Re: IMC New Wales GMAP application, DEP project 1050059-028-AC

Re: Air Construction Permit Application, Dated March 14, 2000
Project: Conversion of GTSP Plant to GMAP
DEP File No. 1050059-030-AC
Site Name: New Wales Facility
Location: 3095 Highway 640, Mulberry, Polk County

RE: Project: Conversion of GTSP Plant to GMAP
FDEP File No. 1050059-028-AC
Site Name: New Wales Facility
Location: 3095 Highway 640, Mulberry, Polk County

Alternative 1

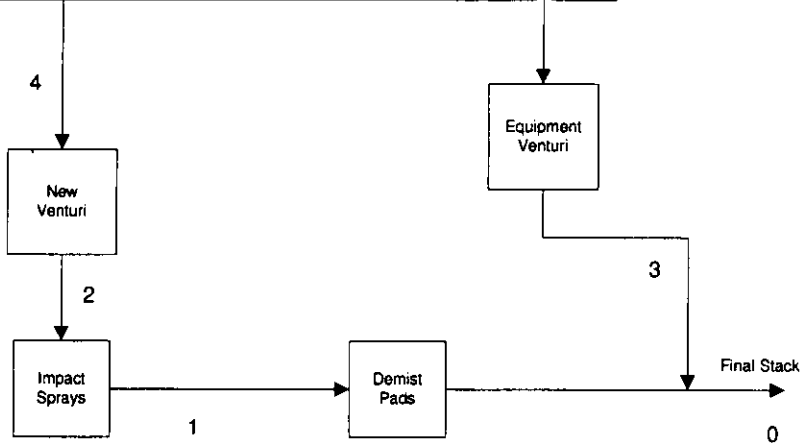
Quite candidly, it's my opinion that none of the proposed alternatives looks like the best approach. Alternative 1 apparently uses re-circulated water on impact spray. The water flow is not clearly established but it seems that the Kimre section would also have re-circulated fresh water. One stage of Kimre will provide three transfer units of fluoride removal and three transfer units of enthalpy removal. If there's no material equilibrium constraint this provides 95% fluoride removal not 70% as referenced.

Also, collection of any liquid or solid fluorides would be 99% at 10 microns size and higher than that for any larger particle or liquid diameter. The overall efficiency is much better than shown. IF THE IMPACT SPRAYS WOULD COLLECT ON A COMPARABLE BASIS WE WOULD LIKE TO SEE THE DATA AS WE HAVE YET TO SEE ANY PERFORMANCE FIGURES THAT COMPARE TO THE KIMRE STRUCTURE.
